ArgonCube 2x2 Installation Planning

ArgonCube 2x2 Installation Meeting on May 15, 2023

Interference between GAR return to the condenser and the Unistrut support for LAr distribution header

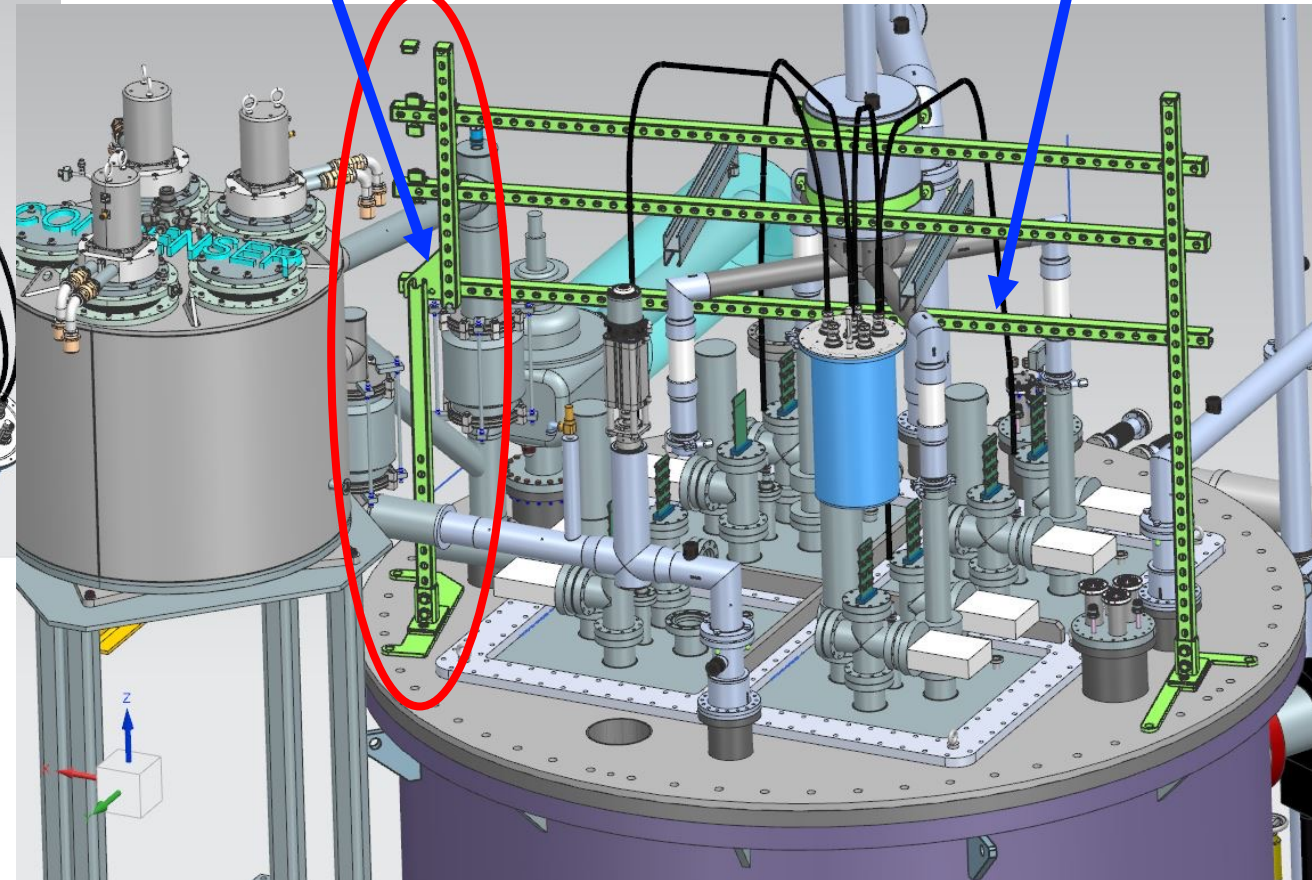
Interference on the top of cryostat

Cut an existing column and shift the upper piece; add a bracket & extra horizontal brace (its height can be adjusted to be useful for cable support as well!)

MPOD DC Power Cable Length Estimate for Charge/Instrumentation Readout

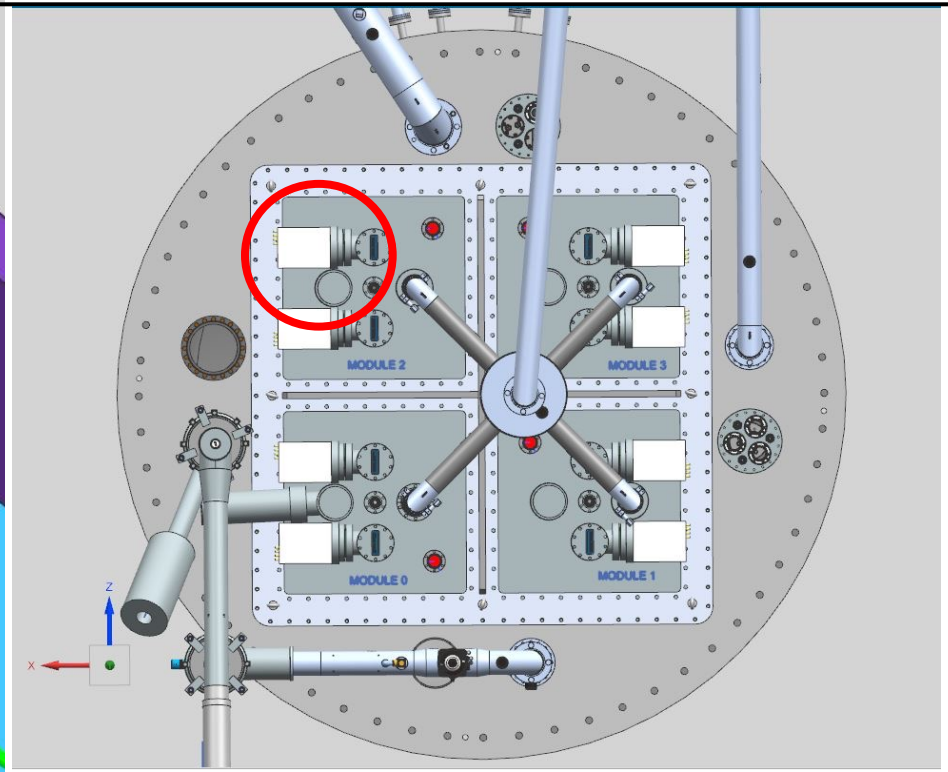
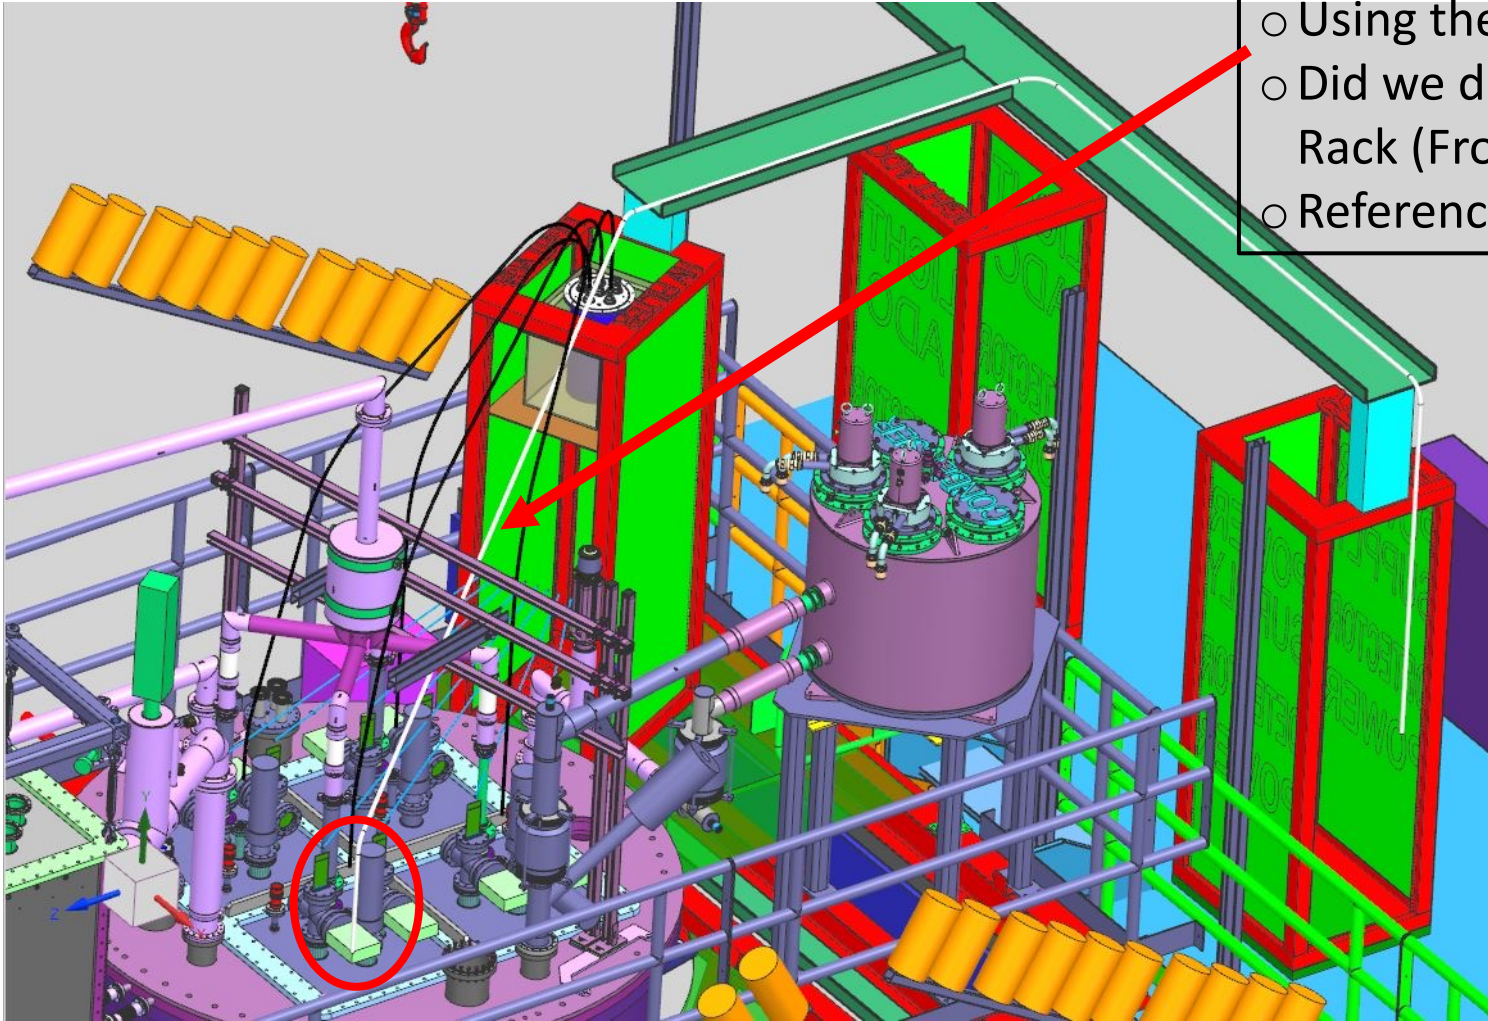
- Using the longest path (white solid line), it's about 30'.
- Did we determine the orientation of Power Supply Rack (Front/Back)?
- Reference: [DUNE-doc-23244](#)

Cryostat Access Platform Details (Handrails, Gates, Step)

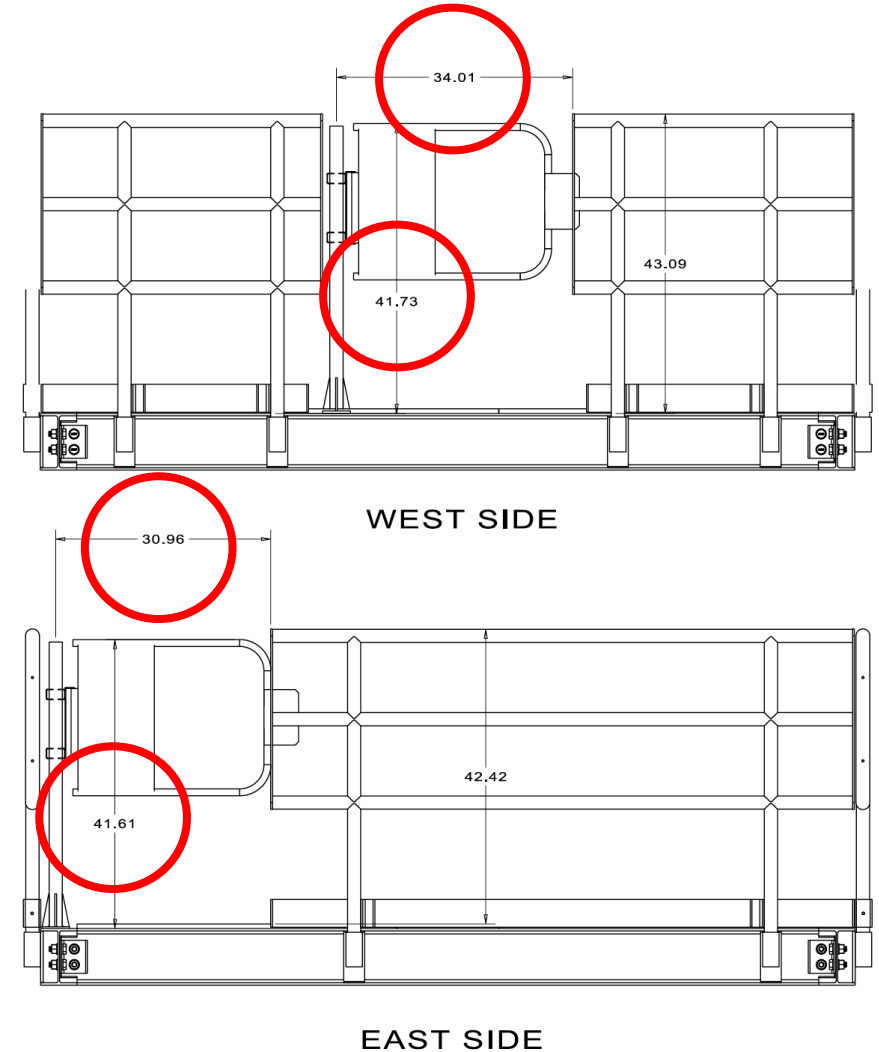
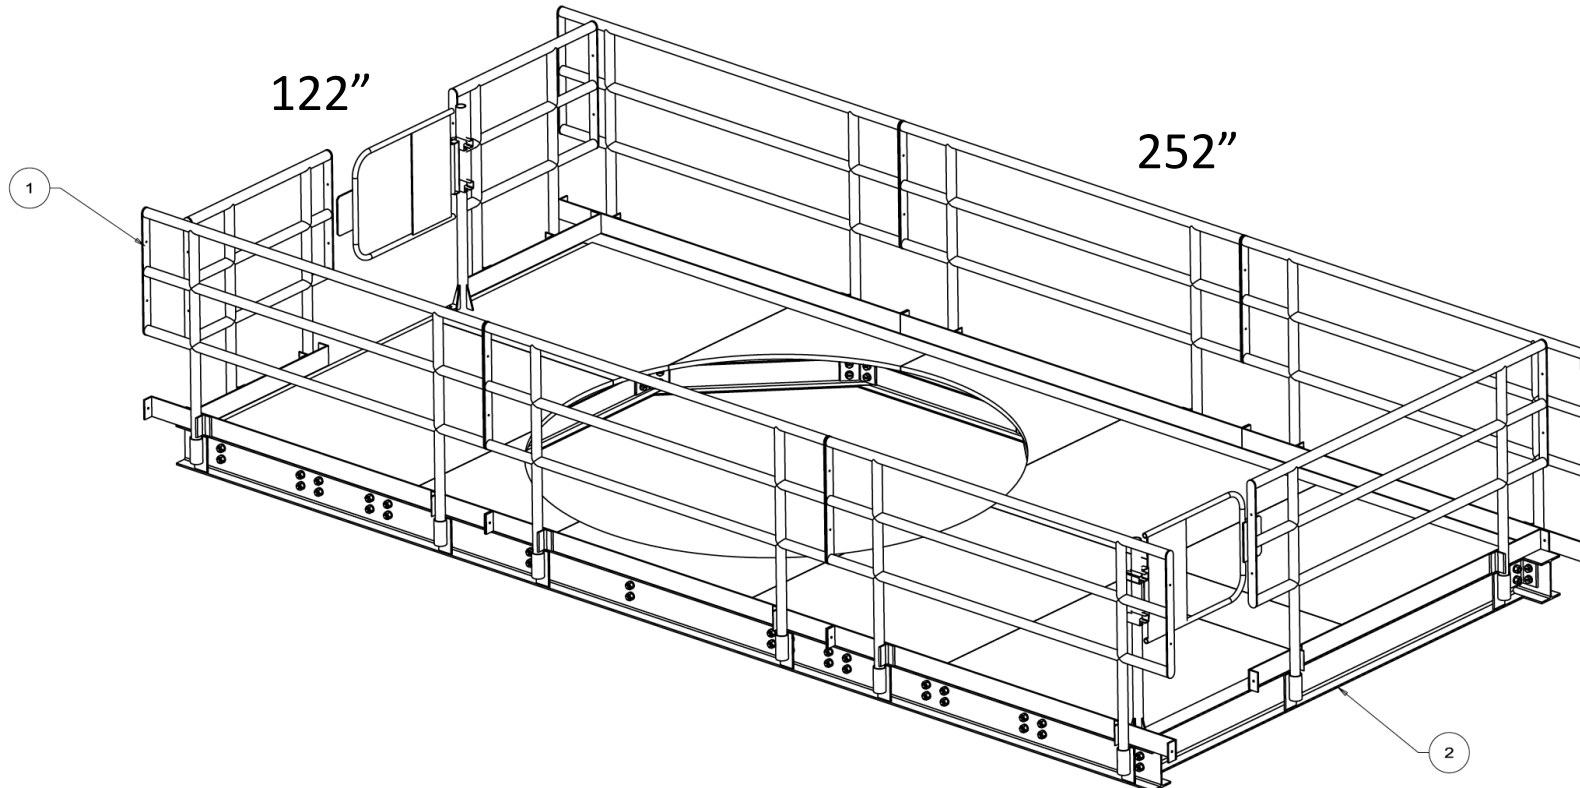
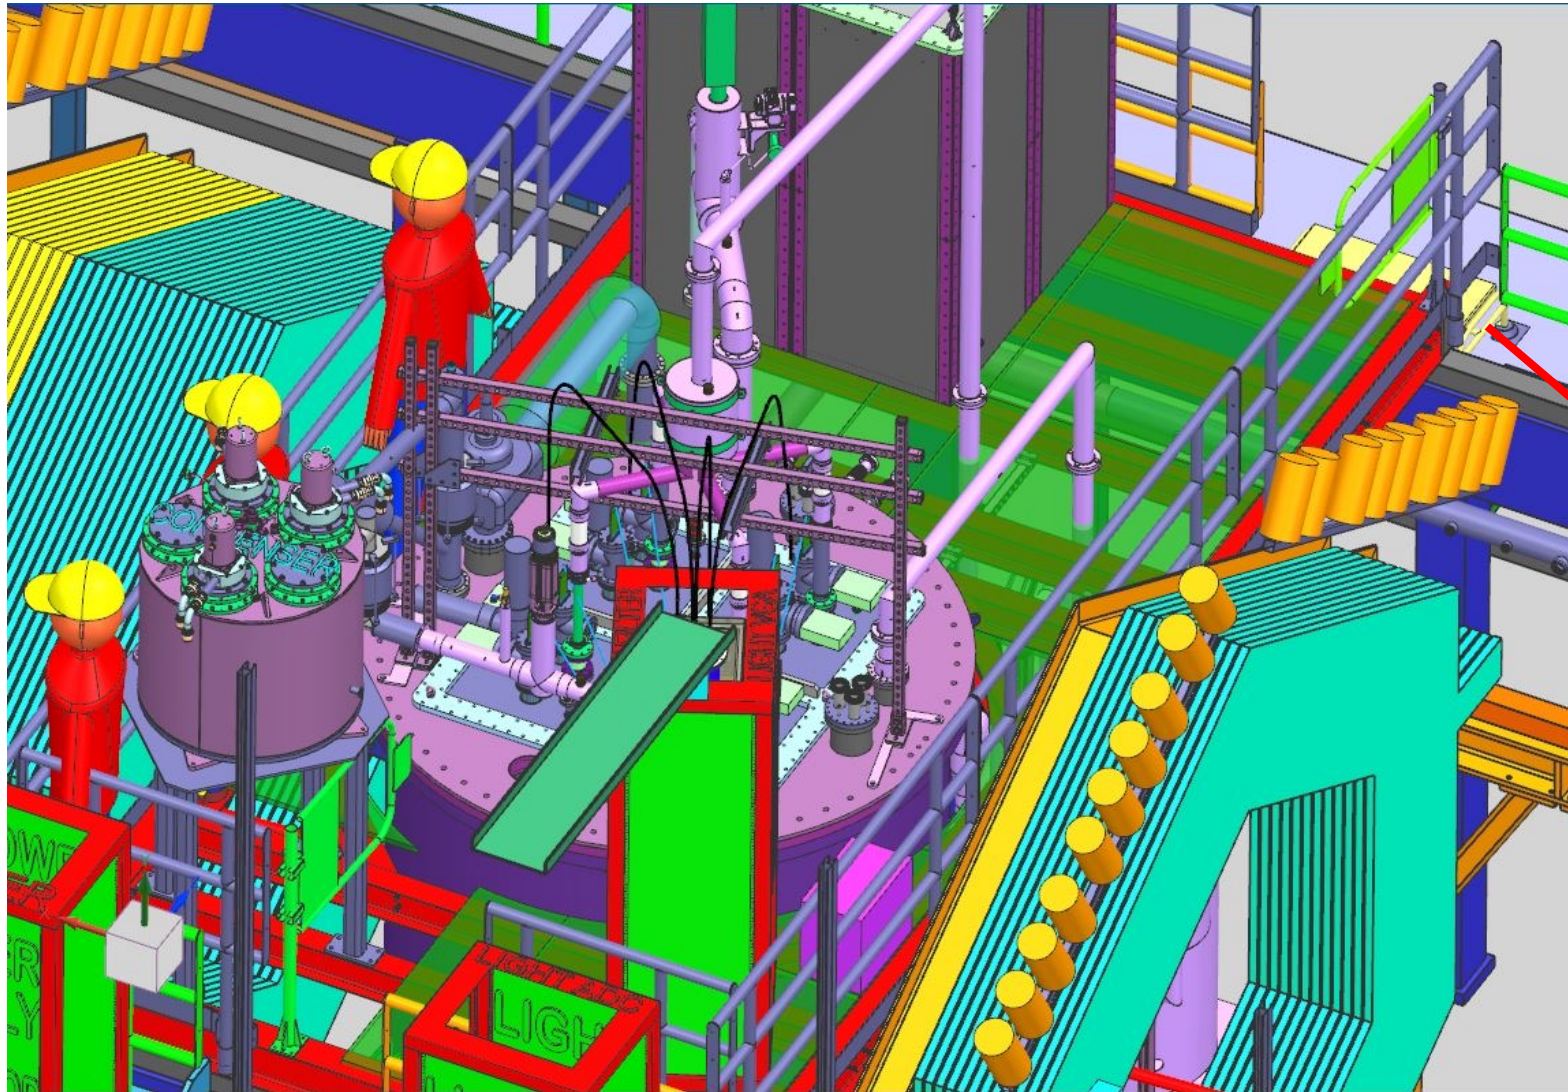
Rules associated with gates:

- Inward (towards the access platform) swing opening gates
- Gate width: 28" (OSHA), 22" (NFPA Life Safety Code)
- Height of gate top rail: 42 ± 3 "

Cryostat Access Platform Details (Handrails, Gates, Step)

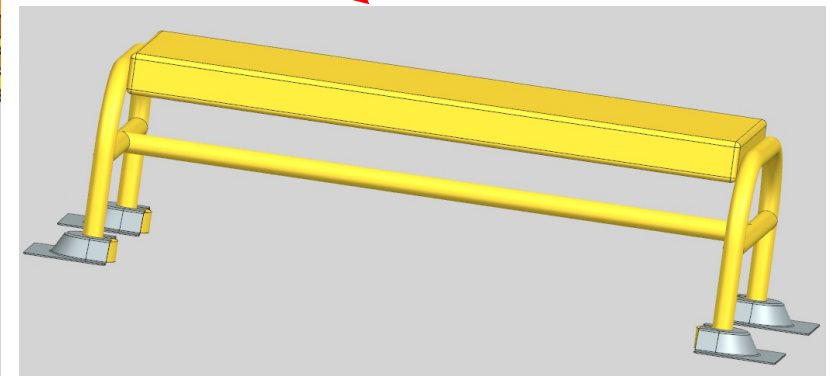
- inward swing opening gates open
- a step stool permanently attached to the test stand (on catwalk) for the East gate

Cryostat Access Platform Details (Handrails, Gates, Step)

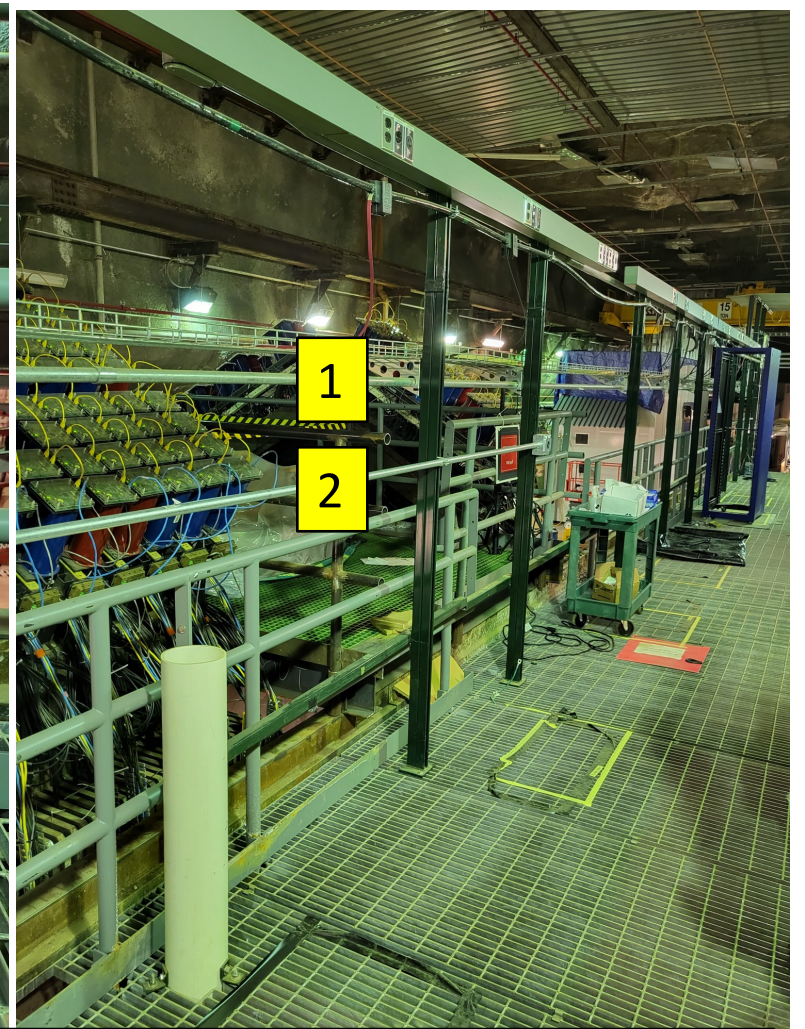
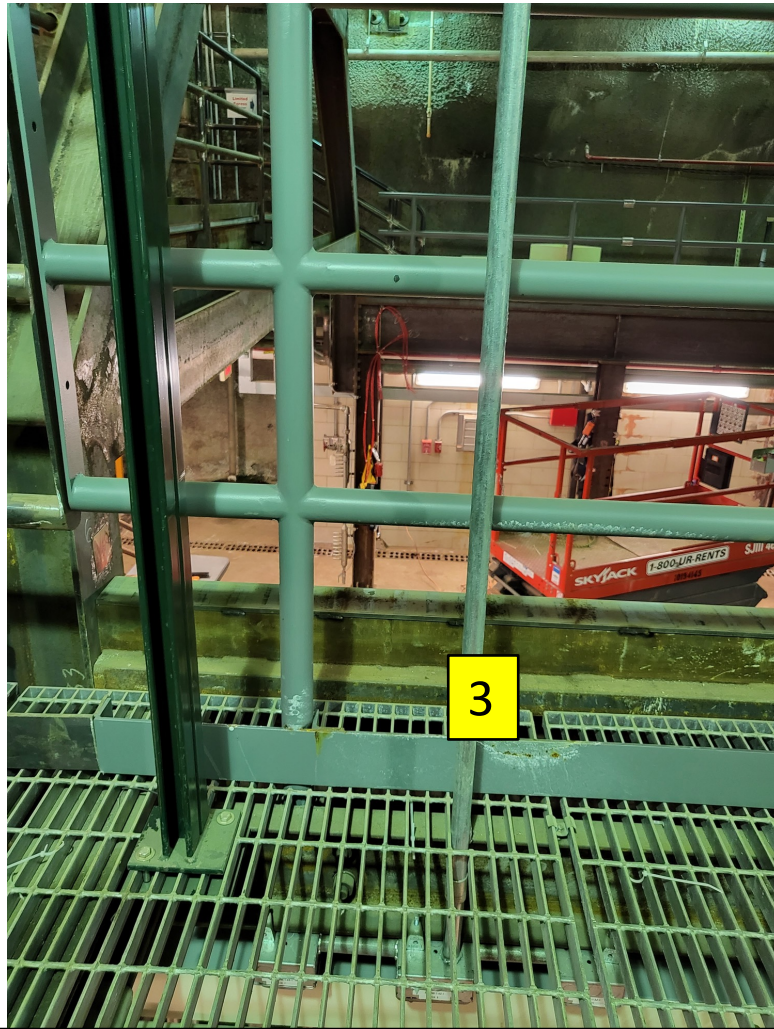
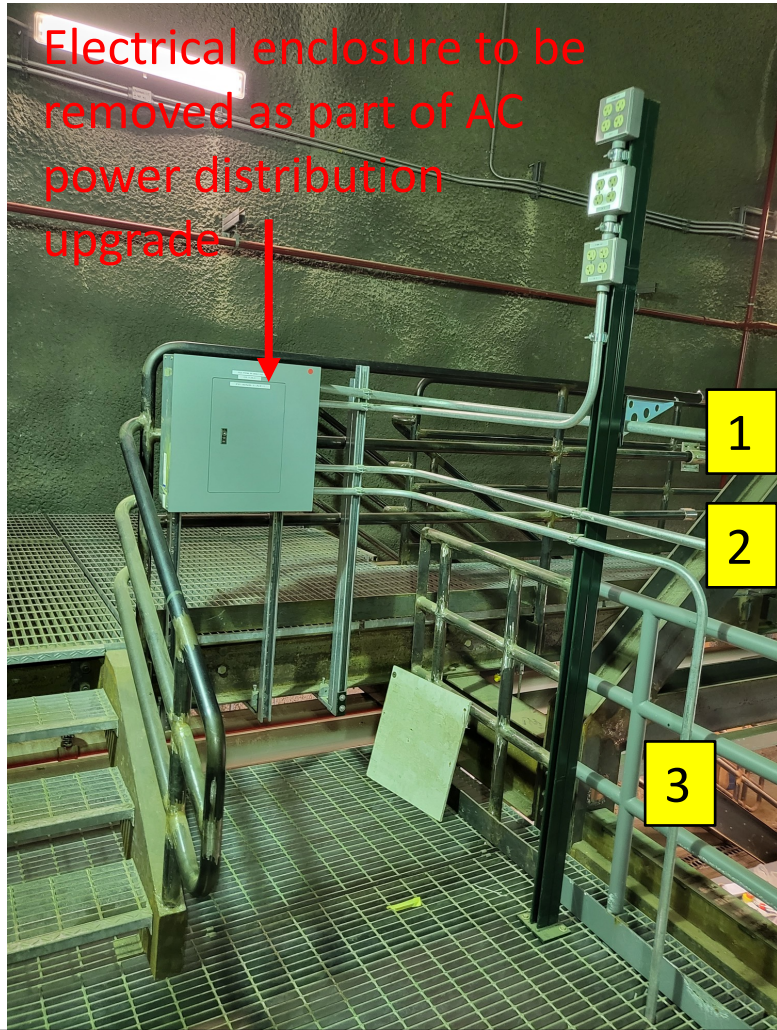
Is there any important reason that we should cut this out?

Do we want to add some piping caps for sharp edges?

West Catwalk Cleanup for Safe Traffic

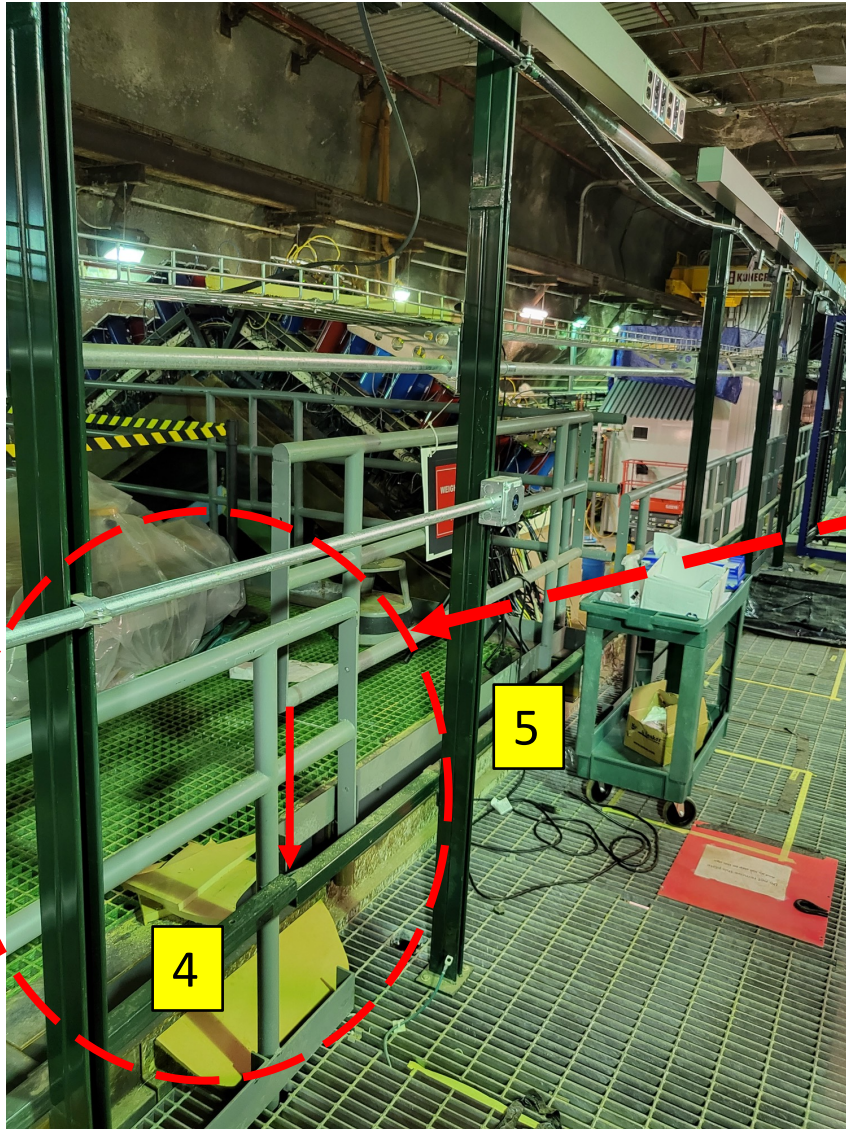
The conduits 1,2 and 3 can't be removed until AC power distribution work as per Matt Micheli!
